# Memorandum

June 17, 2008

**TO:** Columbia River Crossing Task Force  
**FROM:** CRC Pedestrian and Bicycle Advisory Committee (PBAC)  
**SUBJECT:** PBAC Recommendations for World Class Pedestrian and Bicycle Facilities

# Pedestrian and Bicycle Advisory Committee Recommended Pathway on West Side of West Replacement Bridge (Looking North)

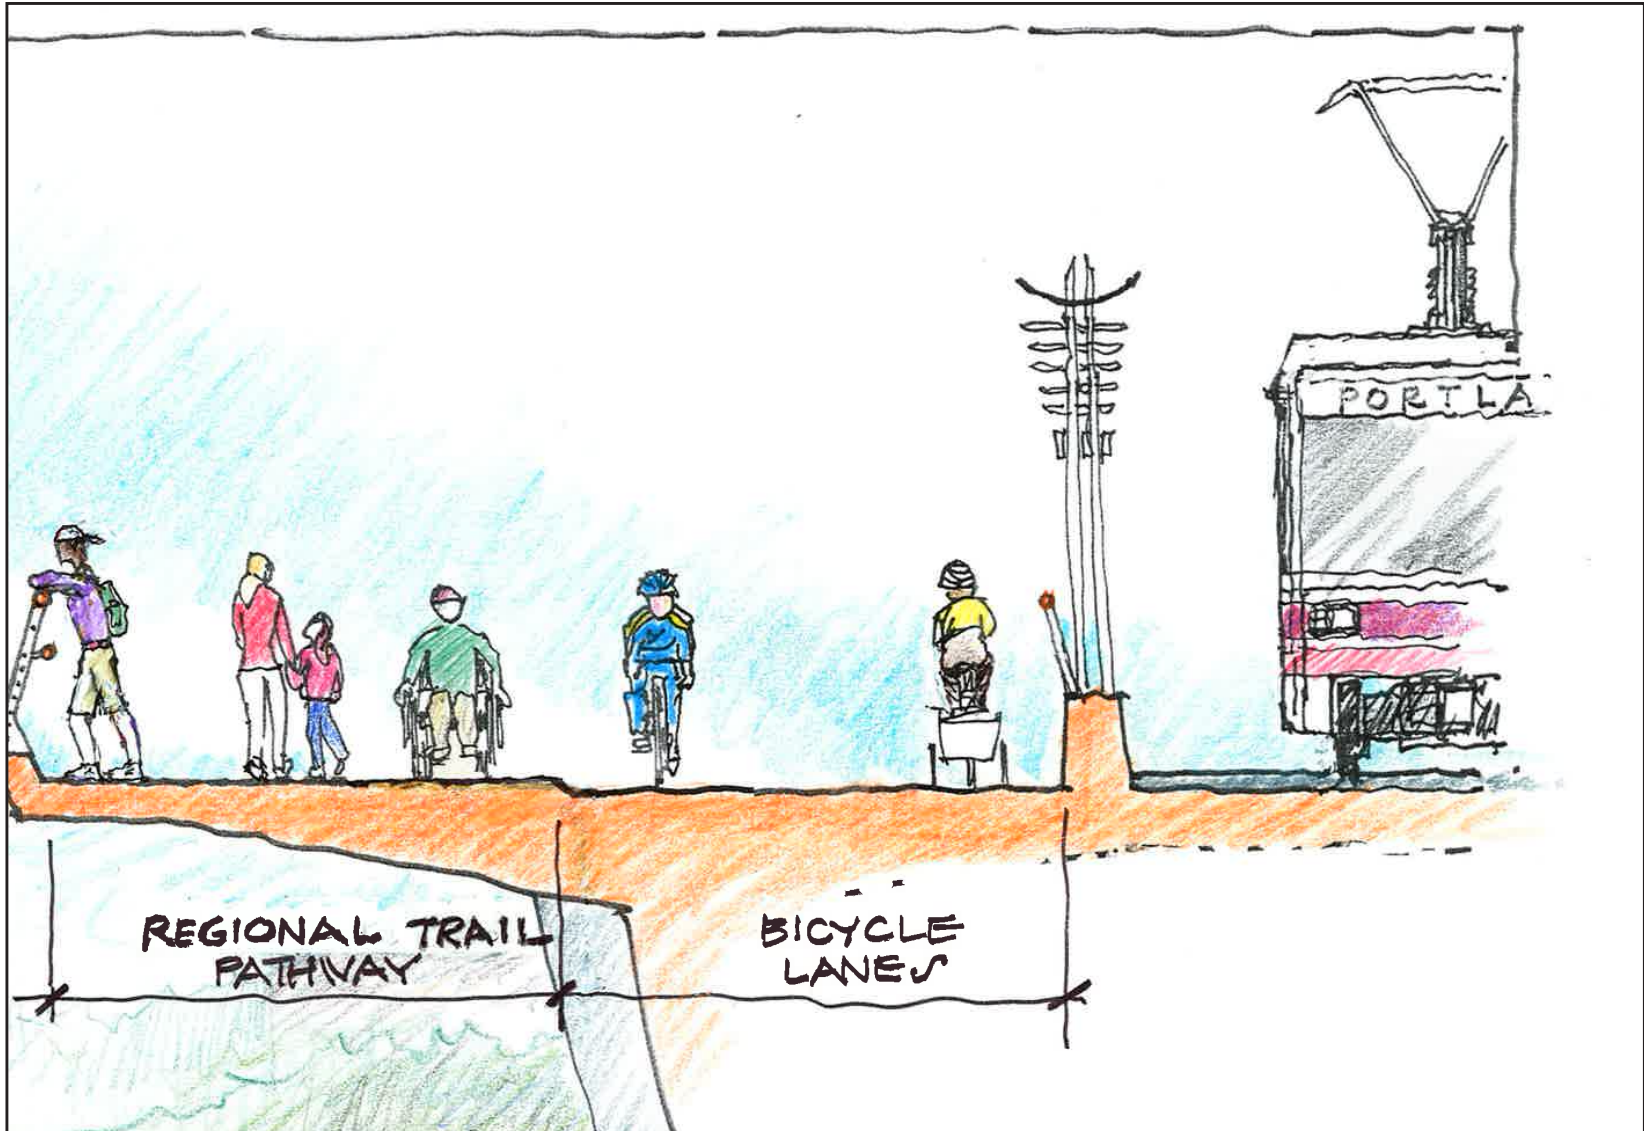
- The overall pathway on the western bridge (adjacent to the transit guideway) must provide separation between recreational users and higher speed bicycle users. To provide this separation, a 12-foot wide regional trail should be provided adjacent to, and to the west of, a pair of six-foot wide bicycle lanes (see attached rendering). These recommended widths are exclusive of potentially needed shy distances, i.e., free and clear of poles and other obstructions to enable safe pedestrian and bicycle movement (a summary of agency standards for multiuse paths, sidewalks and bike lanes is attached).

The regional trail would accommodate pedestrians, persons with disabilities, seniors, families with children, tourists, roller-skaters, and recreational bicycle riders. The adjacent bicycle lanes would be used by bicycle commuters and other faster-moving bicyclists. The regional trail would be at a slightly higher level than the bicycle lanes, but bicyclists in the bicycle lanes would be able to access the trail. Different paving treatments and/or patterns should differentiate the regional trail and the bicycle lanes.
